10 Minshull Street and 11 Bloom Street

SCAFFOLDING OPTIONAL APPRAISAL

LISTED BUILDING CONSENT CONDITION RELEASE 5

Planning Permission 119375/LO/2018 & 119373/LO/2018

PLAN VIEW 4 - 4

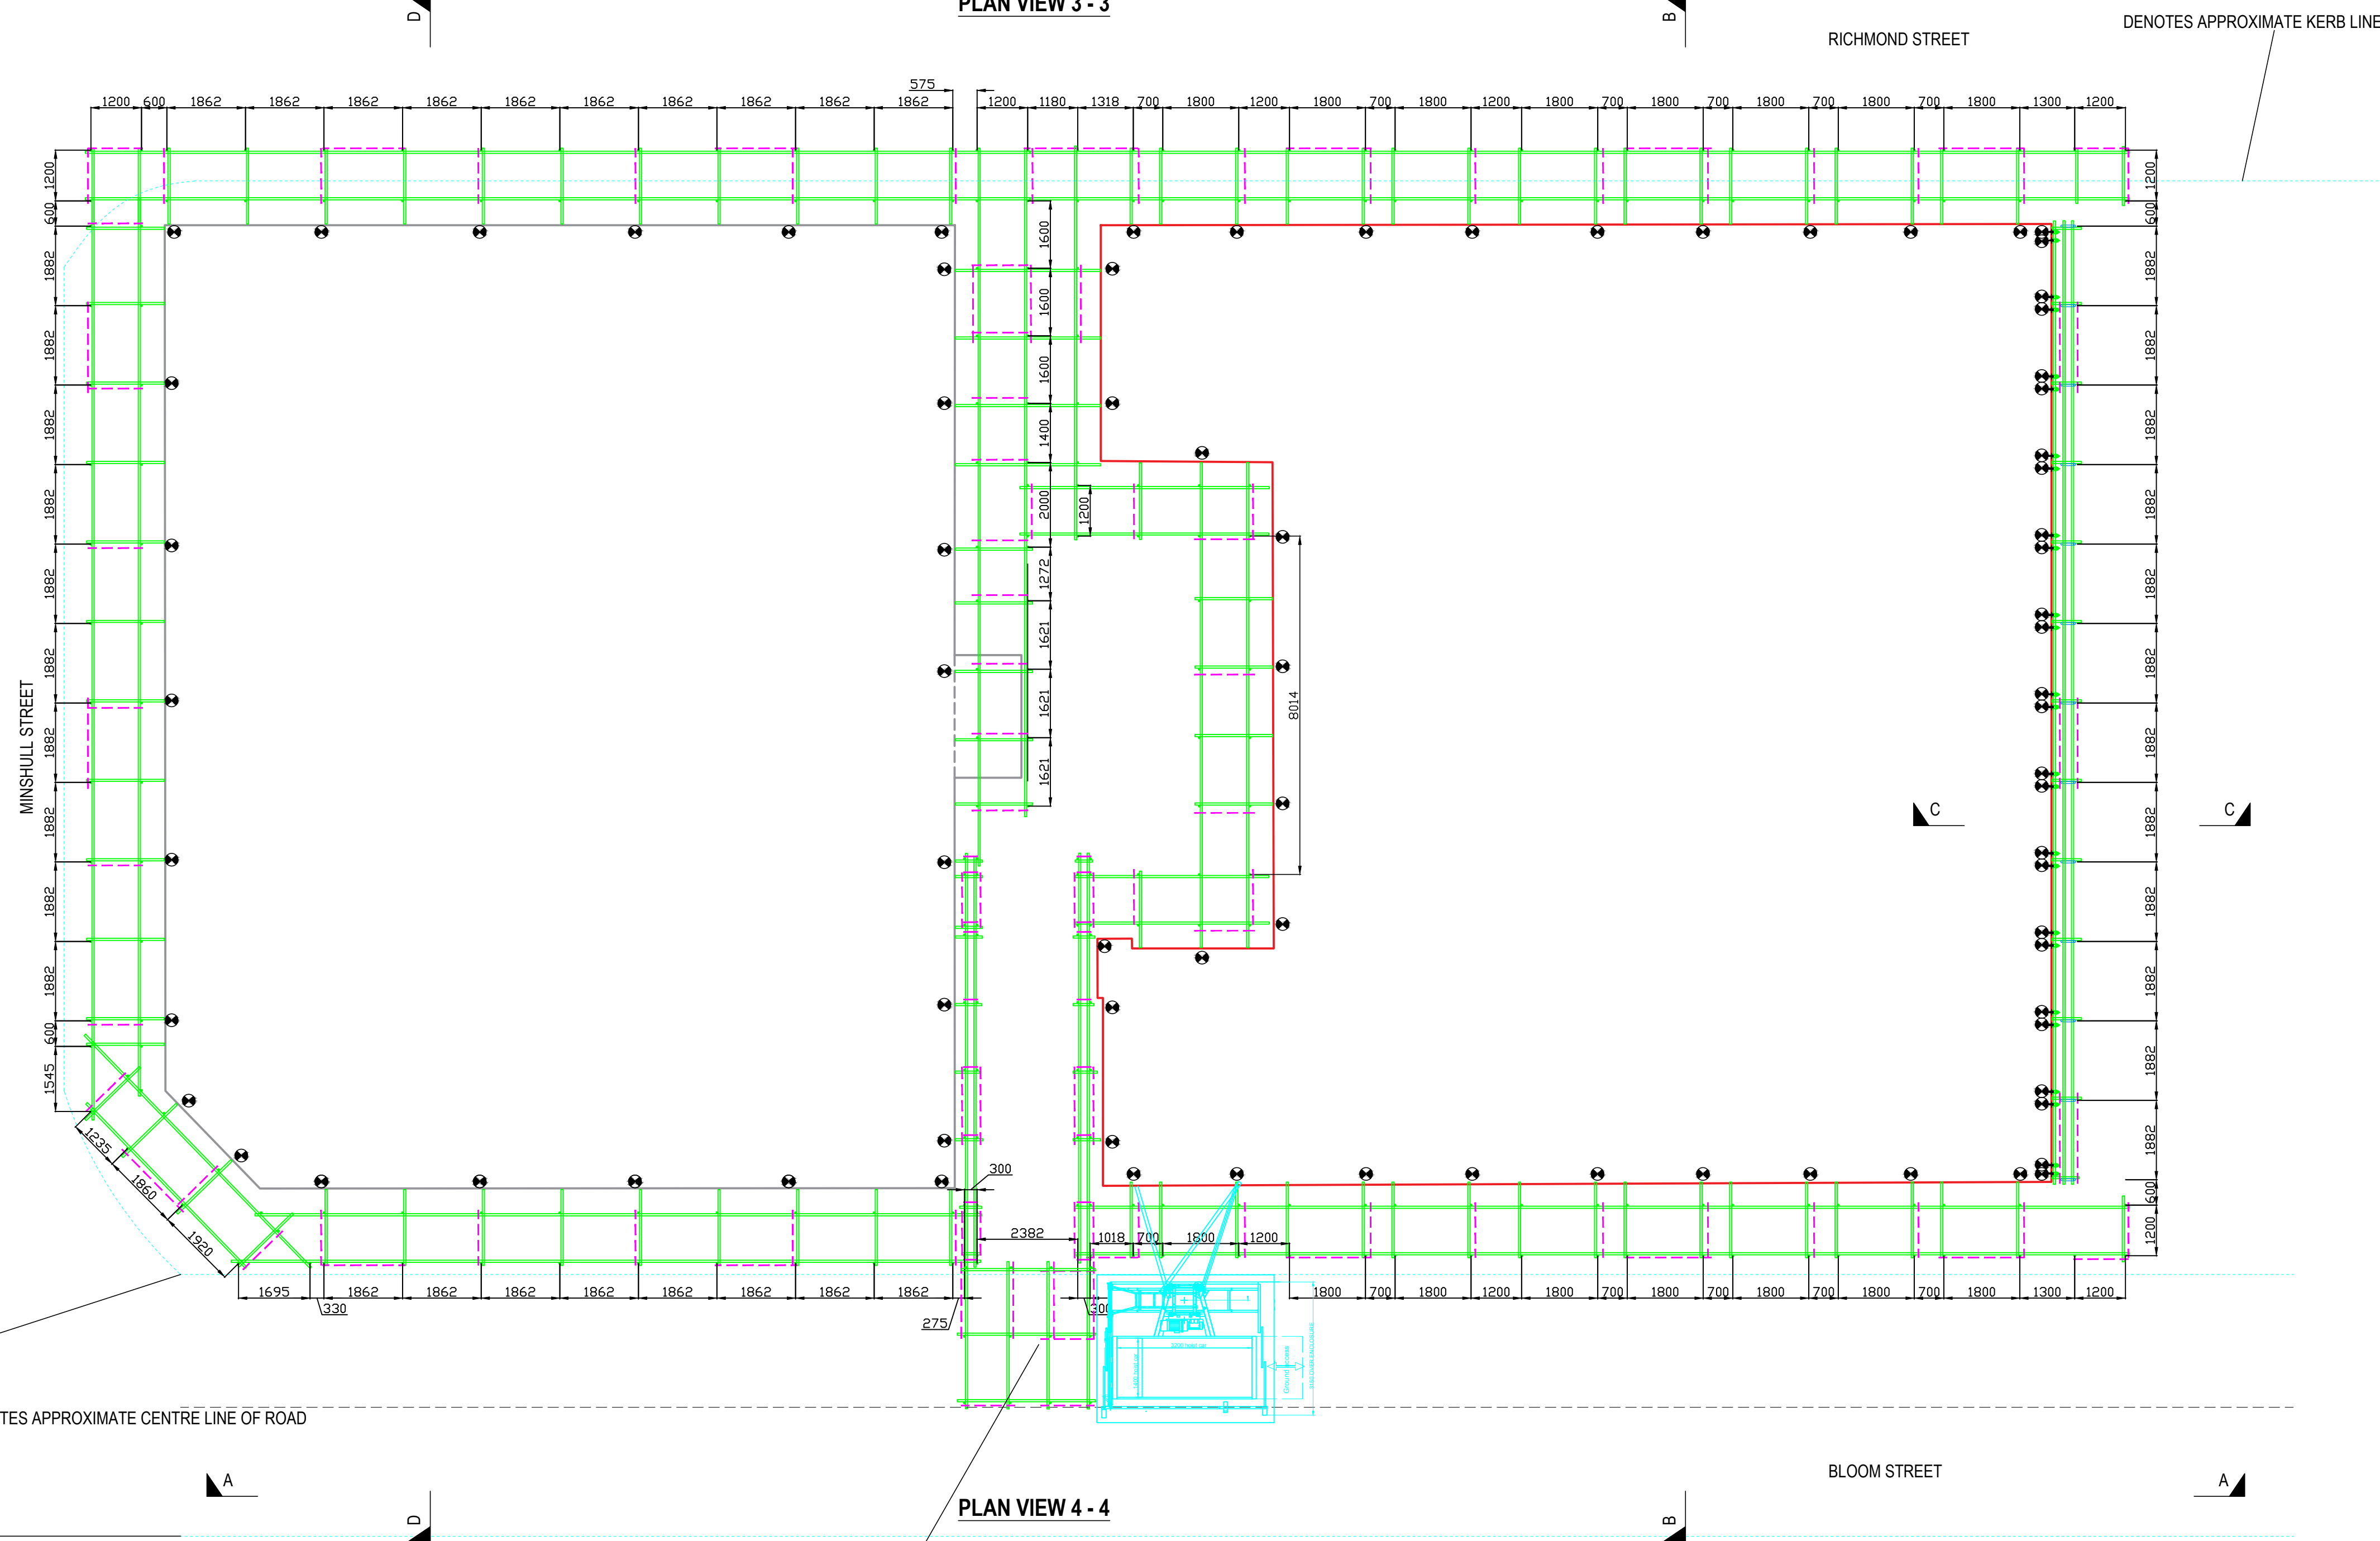
Also, it is noted that the scaffold drawings show 11 Bloom Street is to have a temporary scaffold roof covering, but not Mindel House. If a temporary roof was installed over Mindel, this would allow the roof structure to be more fully investigated from above, with the removal

Comments: refer to section (3) regarding comments on the approach to consolidating this elevation, and on the loads and the basement vaulting etc (noting the scaffold drawings ought to show the vaulted areas of basement in relation to the plan leg loads), and the possibility/benefit of a temporary roof over Mindel House as well as Bloom St.
